ADDENDUM

Project:	Arlington Woods Free Methodist Church Renovation	Post Tender Addendum No.:	A04
Tender #	N/A	No. of Pages:	10 (including cover page)
Project #	1846	Date:	January 07, 2021

Item No.	Drawing or Spec Section	Description
PT-A4.1 General		
PT-A4.1.1	PTM1	Post-Tender Mechanical Addendum PTM1: Refer to the attached PTM1 for new mechanical provisions to add cooling to Kitchen 110. Mount AC-1 unit above existing upper cabinets on east wall of Kitchen 110. Optional location for placement of exterior condensing unit on roof above Kitchen 110 area. Provide precast concrete pavers on 50mm rigid insulation anchored into roof system. Seismically-restrain slab & unit to building structure.
PT-A4.1.2	PTE1	Post Tender Electrical Addendum PTE1: Refer to the attached PTE1 for electrical provisions to supplement new cooling system in Kitchen 110 per PTM1.

ARLINGTON WOODS FREE METHODIST CHURCH RENOVATION

**SANCTUARY KITCHEN RM. PNL
NEW PANEL E**

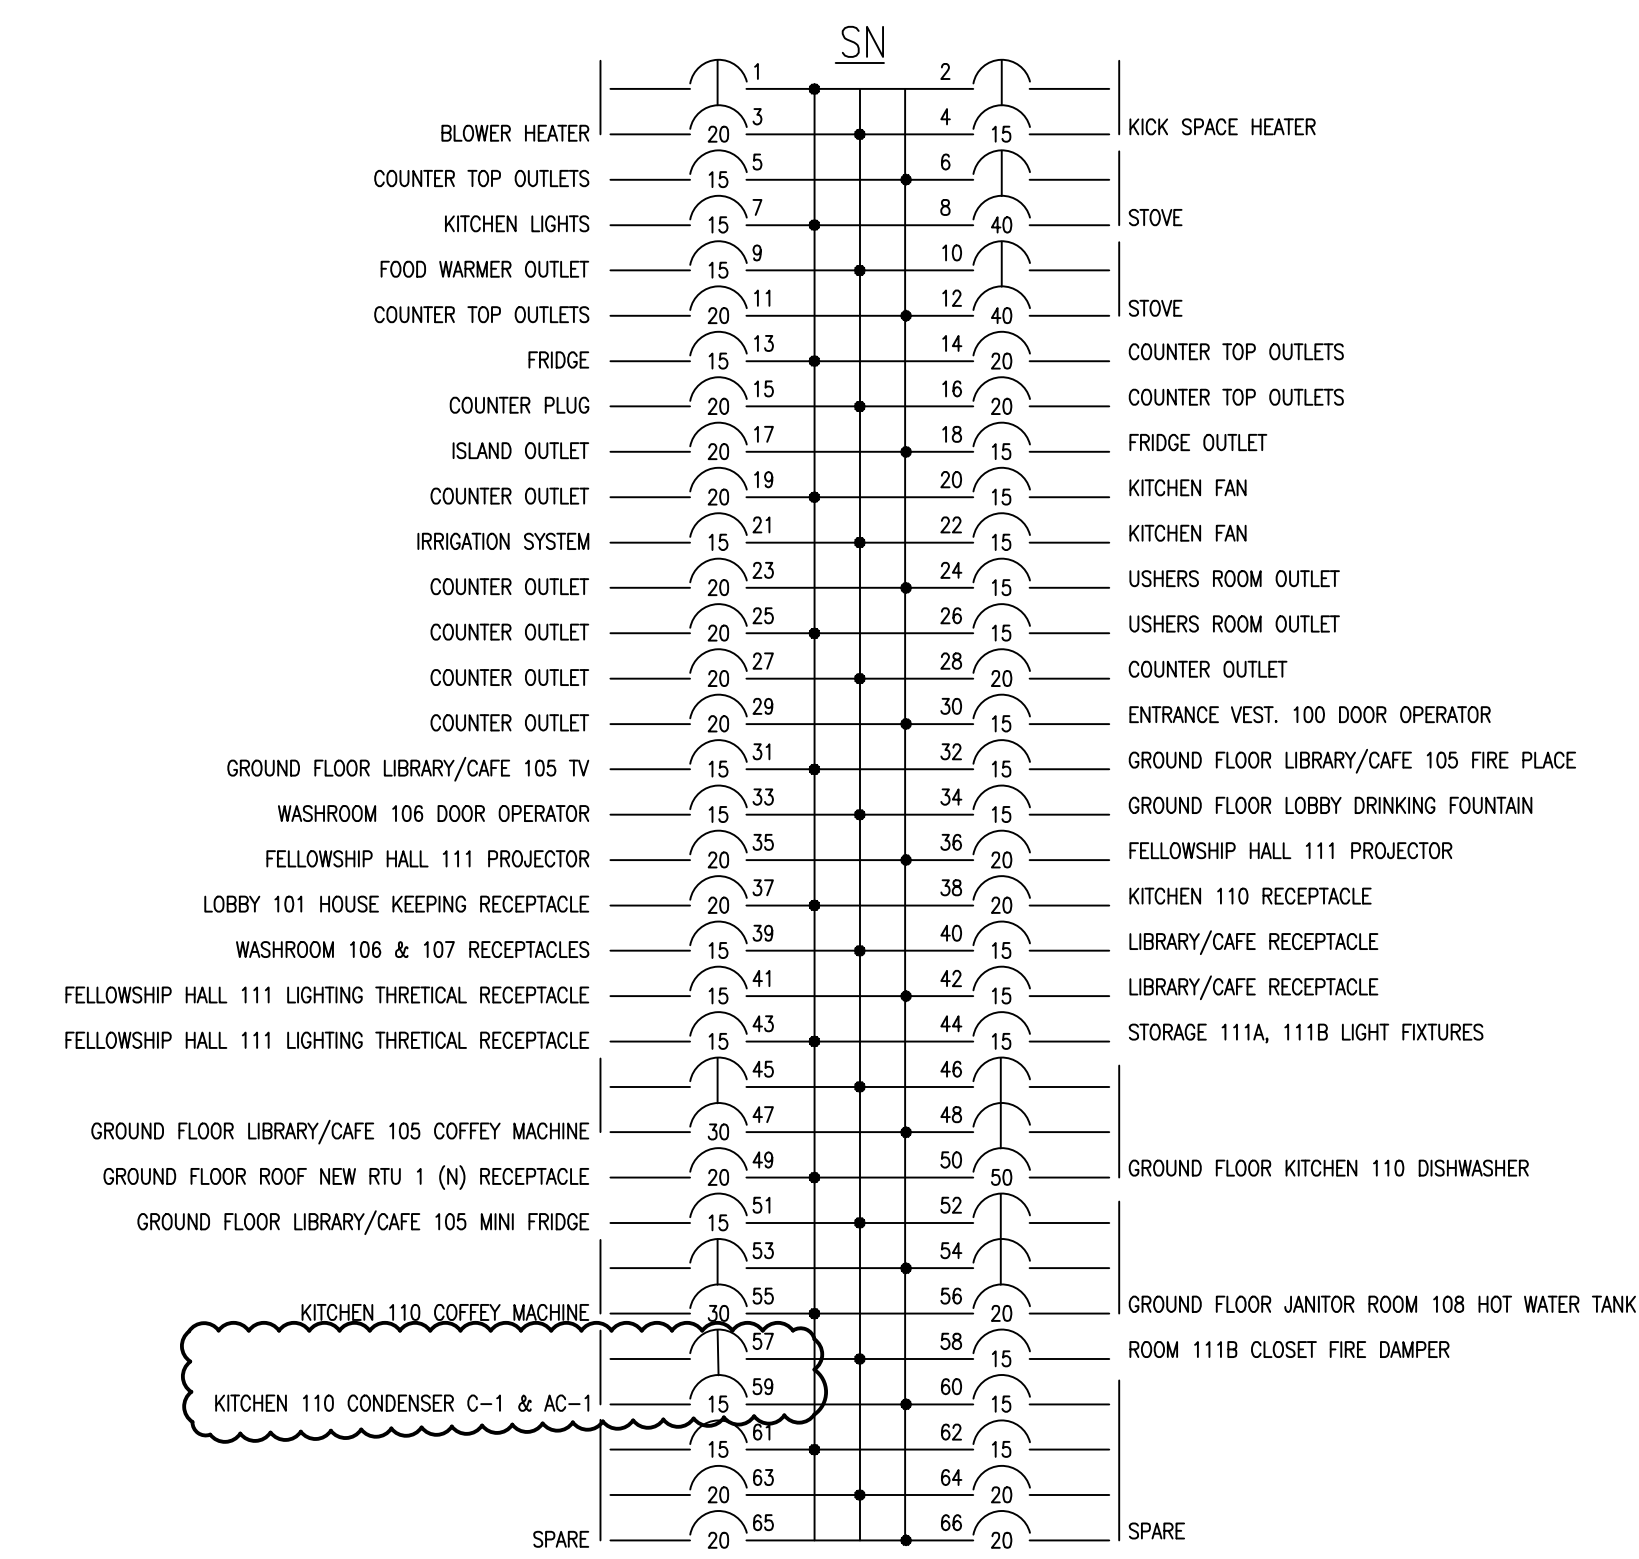
2. Reference Attached Revised Drawing E4:

- .1 Revise 15A-1P breakers (CCT# E-57 and E-59) with 15A-2P breaker (CCT# 57/59) in Kitchen Room Panel E for Kitchen 110 Condenser C-1 and AC-1 as indicated on attached revised Drawing E4.

GROUND FLOOR
ELECTRICAL POWER & SYSTEM NEW WORK LAYOUT
1
E10 1:100

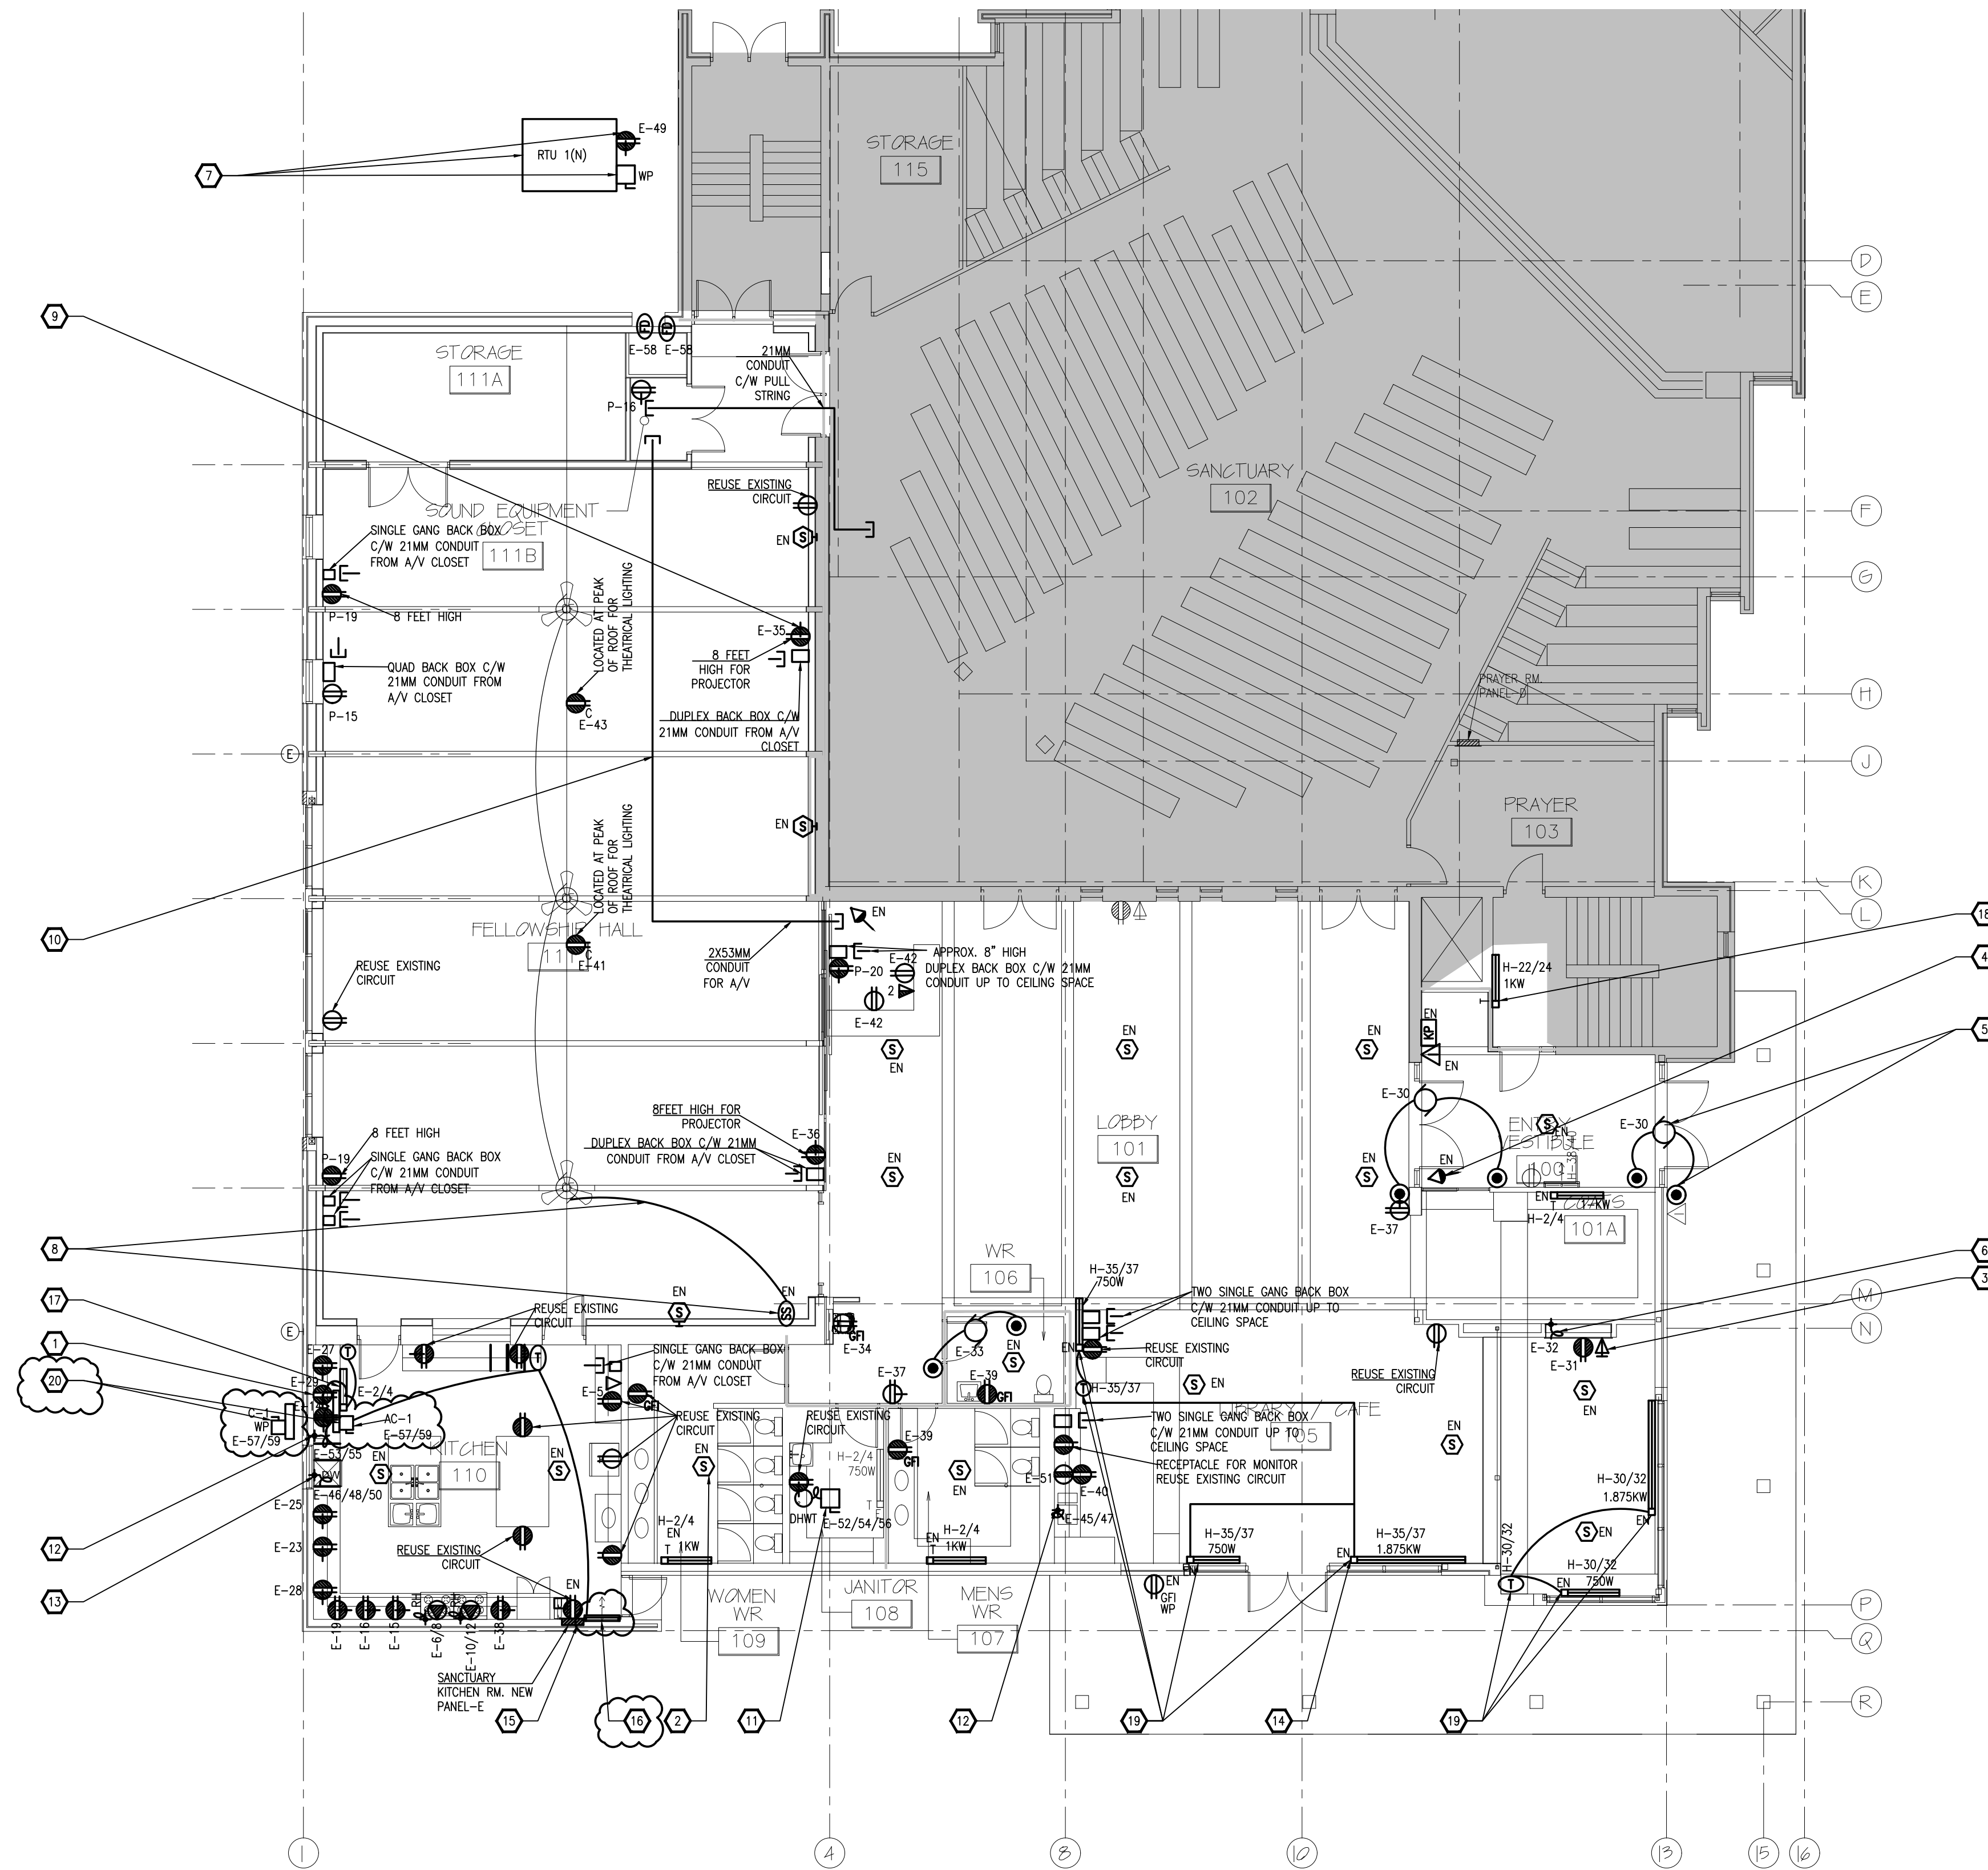
3. Reference Attached Revised Drawing E10:

- .1 Provide weather proof disconnect for kitchen condenser C-1 c/w conduit and wiring. Provide disconnect for Ductless split AC-1 c/w conduit and wiring in Kitchen 110 as indicated on attached revised Drawing E10.
- .2 Delete line voltage thermostat for 3 kW wall mounted force flow heater in Kitchen 110. Revise drawing Note '16' as indicated on attached revised Drawing E10.
- .3 Drawing Note '20' added as indicated on attached revised Drawing E10.

20. CONDENSER UNIT C-1, MCA-14A, 208V, 1-PHASE. PROVIDE WEATHER PROOF DISCONNECT C/W CONDUIT & WIRING. DUCTLESS SPLIT UNIT AC-1, MCA-1A, 208V, 1-PHASE. PROVIDE DISCONNECT C/W CONDUIT & WIRING FROM CONDENSER UNIT C-1. PROVIDE LINE VOLTAGE WIRING FROM IC CN105 TO LOW VOLTAGE TRANSFORMER FOR THERMOSTAT. REFER TO DETAIL 1/E1. REFER TO MECHANICAL DRAWINGS FOR EXACT LOCATION.
